Sheet E1-1-Electrical Symbols, General Notes, Schedules, and Details

ADDENDUM #3

THE WICHITA AIRPORT AUTHORITY
COLONEL JAMES JABARA AIRPORT

SANITARY SEWER AND WATER DISTRIBUTION SYSTEM
SOUTHWEST AREA SITE DEVELOPMENT IMPROVEMENTS

2 ELECTRICAL LIFT STATION PLAN
SCALE: 1/4" = 1'-0"

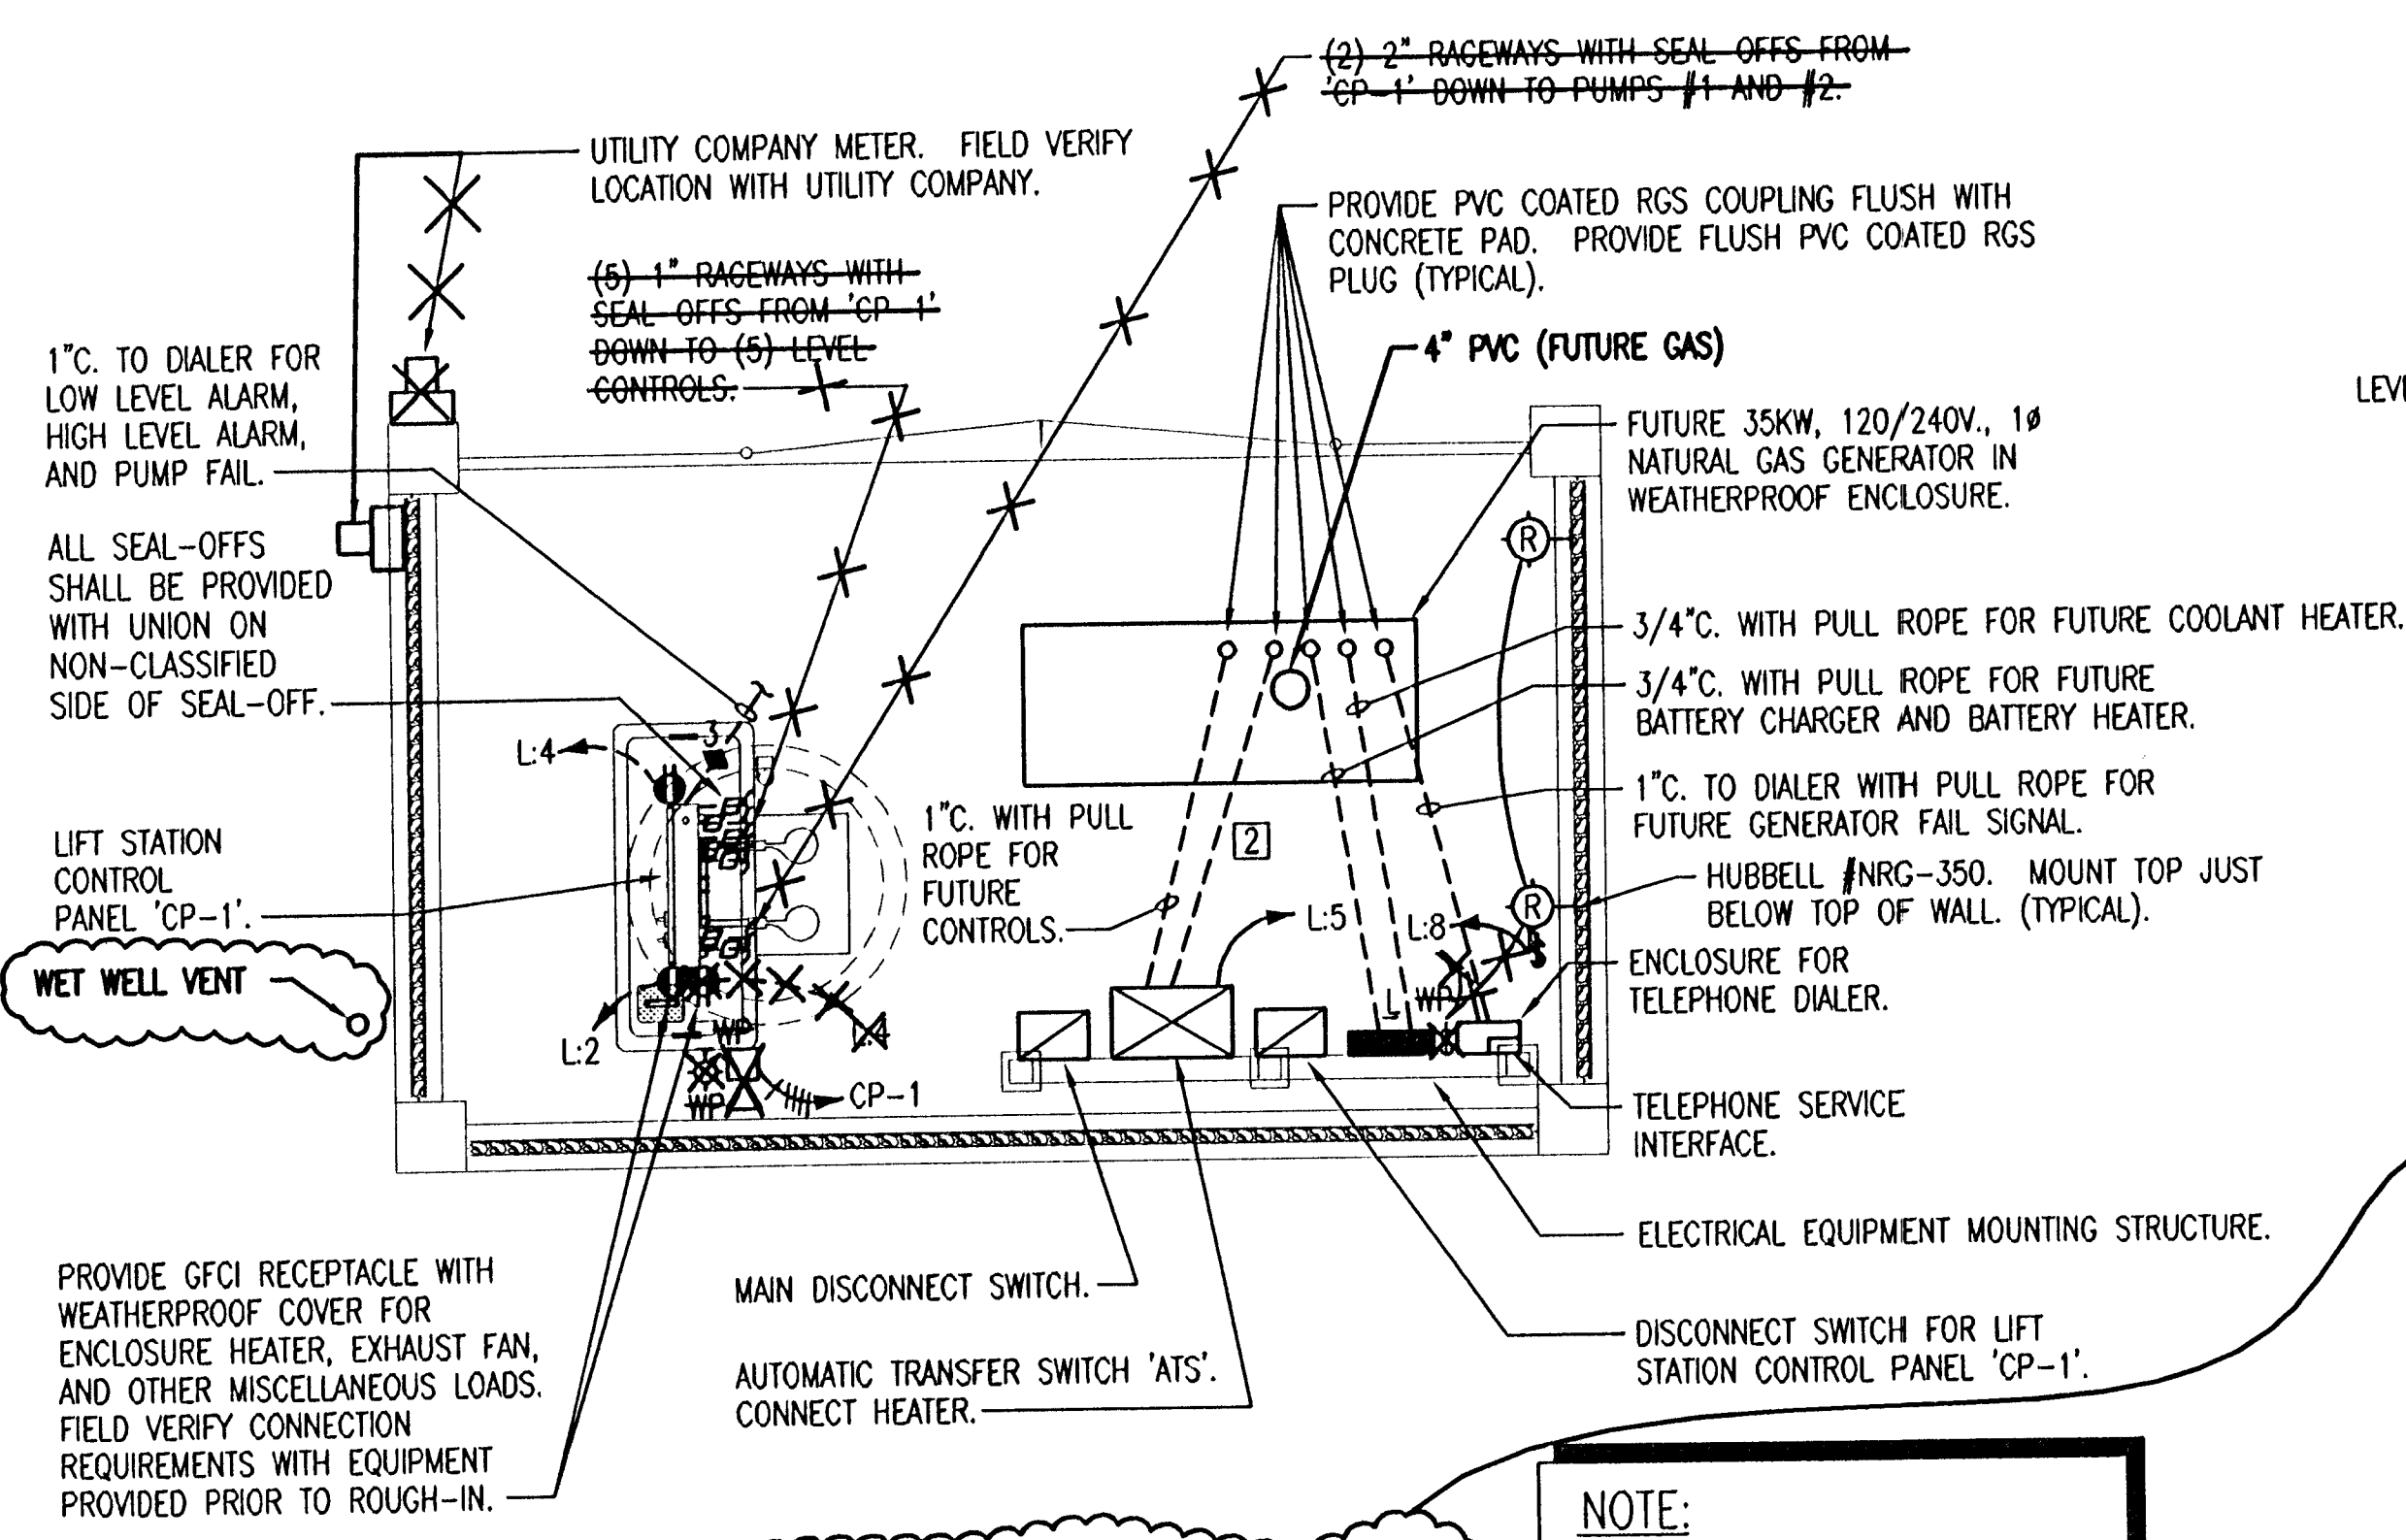
Electrical Lift Station Plan, ADD the following note:
"Contractor shall provide 1-1/2" pipe for natural gas service line.
Pipe shall be plastic coated steel pipe, ASTM A 120 or A 53, Schedule 40, seamless Grade B, black steel pipe.
Pipe shall be coated with X-Tru Coat. Service line shall be installed underground from 3' outside of concrete wall, under the wall, and shall terminate 6' above concrete pad near future generator area.
Location shall be coordinated with Owner and Engineer.
Pipe shall be capped on both ends and fittings shall be coated with X-Tru Coat"
